Boire Associates Inc.*Geotechnical Engineering Solutions*520 NW 4th Street
Corvallis, Oregon 97330
Tel: 541.753.5344
Fax: 541.753.5347**Addendum #2 (Technical Memorandum)**

To: Jim Hurst	From: Todd Boire, P.E.
Fax: 541.902.7999	Pages: 1
Phone: 541.997.5157	Date: July 13, 2004
Re: Shelter Cove	Cc:

This technical memorandum addresses questions raised by various regulatory agencies during preliminary design meeting. Comments made herein should be considered as an addendum to our prior work.

Figure 8-1. Schematic illustration of an established, growing vegetated riprap revetment.

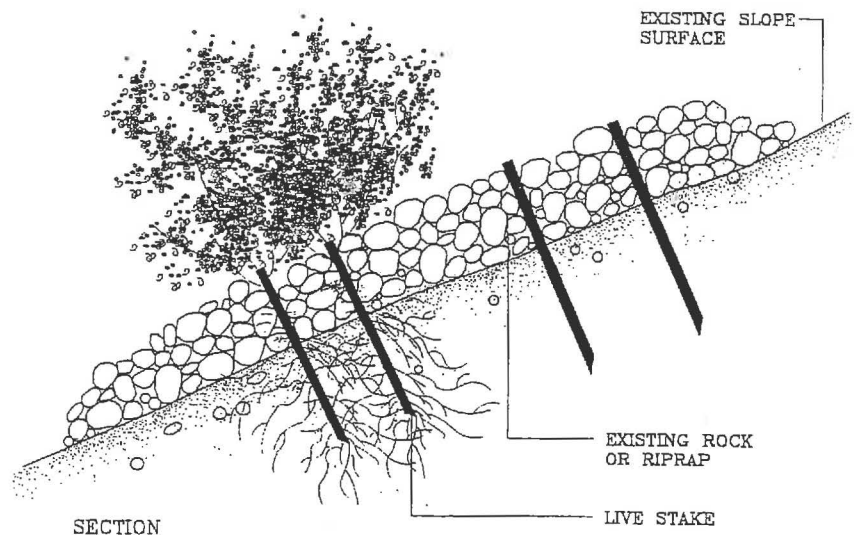
One regulatory agency will require vegetated planting within the riprap for the purposes of shading. This addition is not preferred by us but would be allowed. As a side, it should be noted that the specific surface area of a particle increases geometrically with decreasing diameter. Therefore, new riprap would already be considerably less thermally active than the existing sand. In any case, we would expect the river would be unaffected by the shore protection given its volume and direct contact with the ocean.

Live cuttings placed in this manner should extend into the soil beneath the stone armor, as illustrated in Figure 8-1. The objective is to have these live cuttings root in the soil beneath the riprap, thus reinforcing the bank, anchoring the riprap, and improving drainage by extracting soil moisture.
